Item Name: Dual Cargo Mirror Assembly, 6 inch Round

DART SERVICE INSTRUCTION

TO AMEND INSTALLATION INSTRUCTIONS D206-558 REV. C OR EARLIER
AND INSTRUCTIONS FOR CONTINUED AIRWORTHINESS ICA-D206-558 REV. 0

IT HAS COME TO DART'S ATTENTION THAT A DIFFERENT CABLE IS REQUIRED WHEN INSTALLING THE DART D407-558-045/-047 SINGLE/DUAL CARGO MIRROR ASSEMBLY ON A BHT 407GX AIRCRAFT.

3.0 CARGO MIRROR INSTALLATION

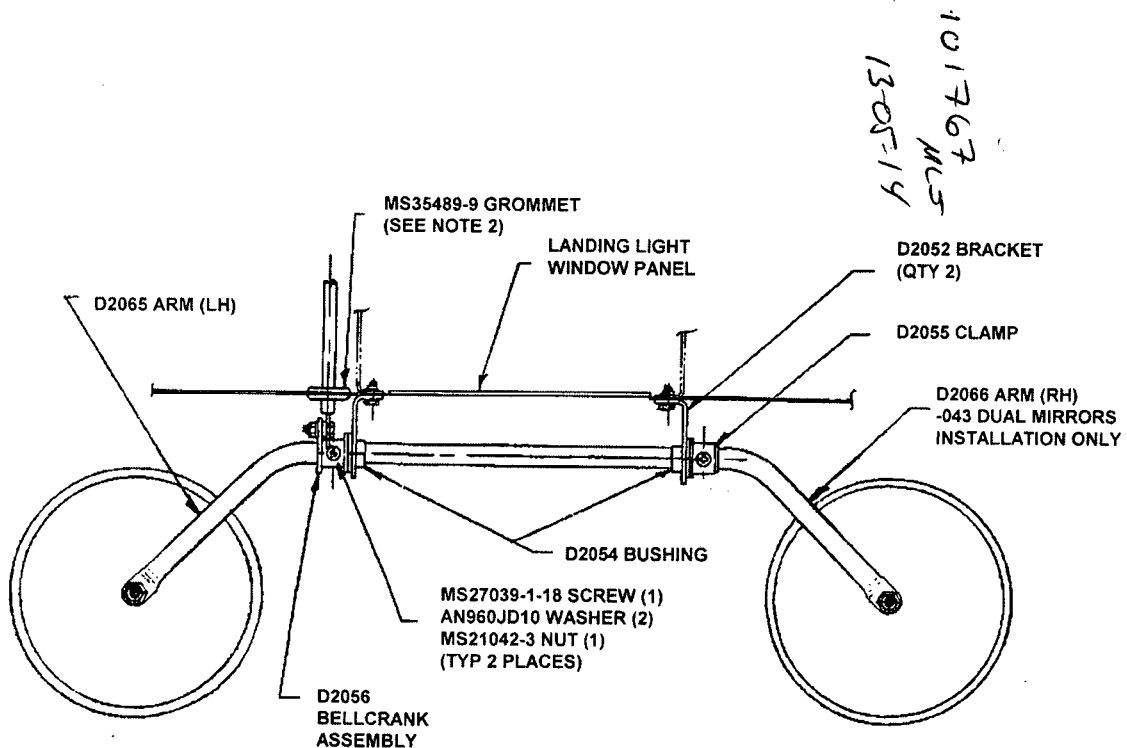
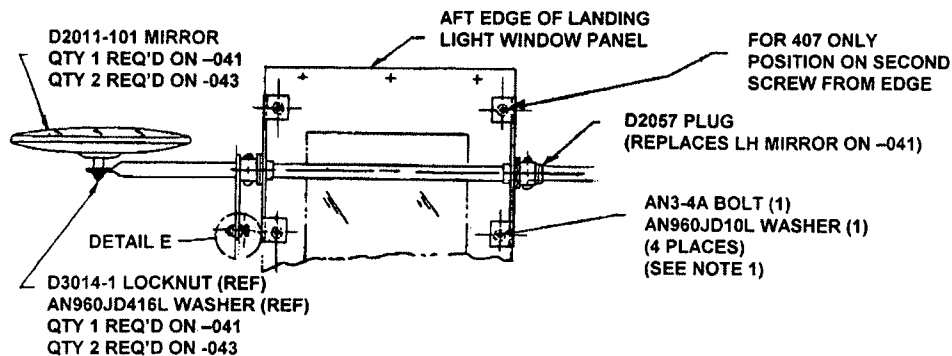
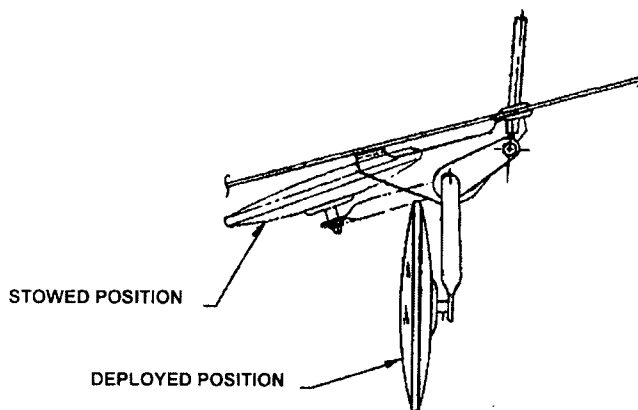
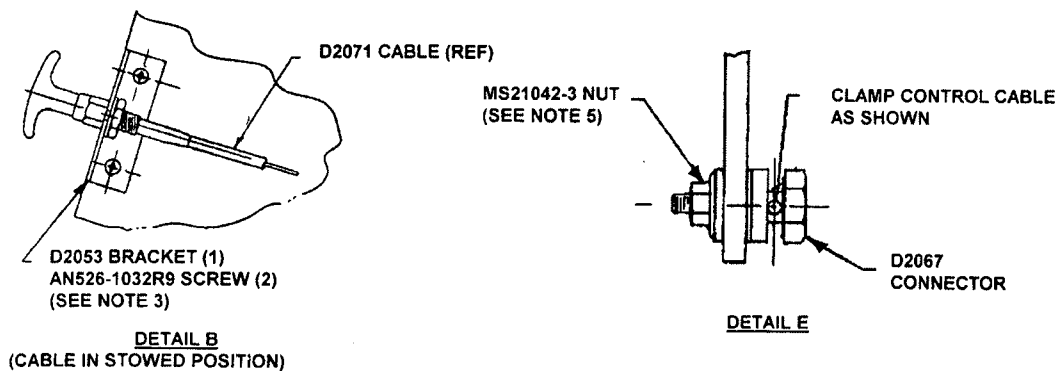
THEREFORE, IN D407-558-045/-047 AT CHG 003 OR LATER, THE D2071-3 CABLE ASSEMBLY HAS BEEN REPLACED WITH THE D2071-5 CABLE ASSEMBLY.

THE D3778-1 BRACKET HAS ALSO BEEN REPLACED WITH THE D3778-3 BRACKET FOR BETTER PILOT COMFORT.

1. Install D206-558-041/-043 cargo mirror assembly using AN3-4A bolts and AN960JD10L washers. Pickup existing anchor nuts in 4 places.
2. Install D2067 connector onto D2056 bellcrank assembly to locate hole for MS35489-9 grommet. With the mirror in the deployed position, mark and drill $\varnothing 0.125$ " (3.2mm) hole in landing light window panel where the grommet should be located. Open pilot hole to $\varnothing 0.563$ " (14.3mm). Install grommet.
3. Install D2053 bracket using AN526-1032R9 screws. Pickup on existing anchor nuts.
4. Position D2071 cable as shown. Install MS21919DG5 clamps using AN526-1032R9 screws where required. Pickup existing rivnuts or anchor nuts if available.
5. Install D2071 control cable using D2067 connector. Connector should rotate freely in bellcrank when MS21042-3 nut is torqued and cable clamped
